Item Name: Tunnel Top Panel Assembly

D3650-041 TUNNEL TOP PANEL ASSEMBLY

DRAWING NO. D3650	TITLE TOP PANEL ASSEMBLY	REV. C	DART AEROSPACE LTD ENGINEERING ORDER		D.E.O. NO. D3650-C-1	SHEET NO. SHEET 1 OF 1	SCALE NTS
DRAWN CP	CHECKED	MFG. APPR.	APPROVED	DE APPR.			
DATE 09.06.12	DATE 06.06.15	DATE 09.06.15	DATE 09/06/15	DATE 09/06/15

TO AMEND D3650-5 FWD PANEL:

DETAIL F C5-7
SCALE 3.5X

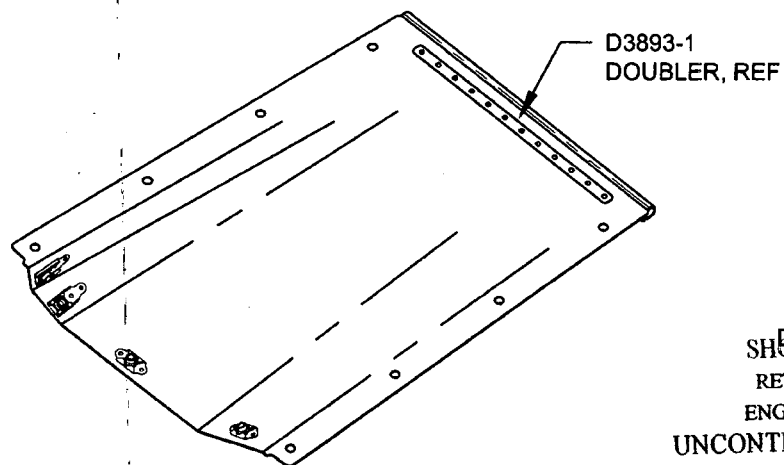
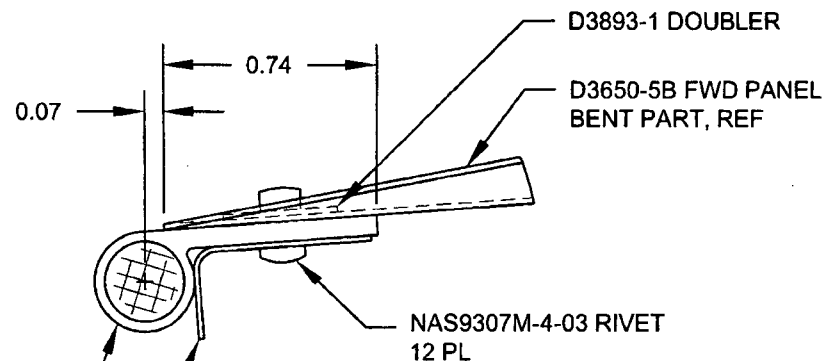
REF PAR 09-008. THE QTY(12) NAS1149CN432R WASHERS ARE REPLACED WITH QTY(1) D3893-1 DOUBLER. THE QTY(12) MS20615-4M5 RIVETS ARE REPLACED WITH QTY(12) NAS9307M-4-03 RIVETS. LOCATION OF THE DOUBLER IS SHOWN IN THE AMENDED DETAIL F (DWG SHEET 7) BELOW. THE PARTS LIST FOR D3650-5 IS AMENDED AS FOLLOWS:

IS:

QTY	PART NUMBER	DESCRIPTION
-5		
1	D3893-1	DOUBLER
12	NAS9307M-4-03	RIVET (OR CR3523-4-03)

WAS:

QTY	PART NUMBER	DESCRIPTION
-5		
12	NAS1149CN432R	WASHER
12	MS20615-4M5	RIVET
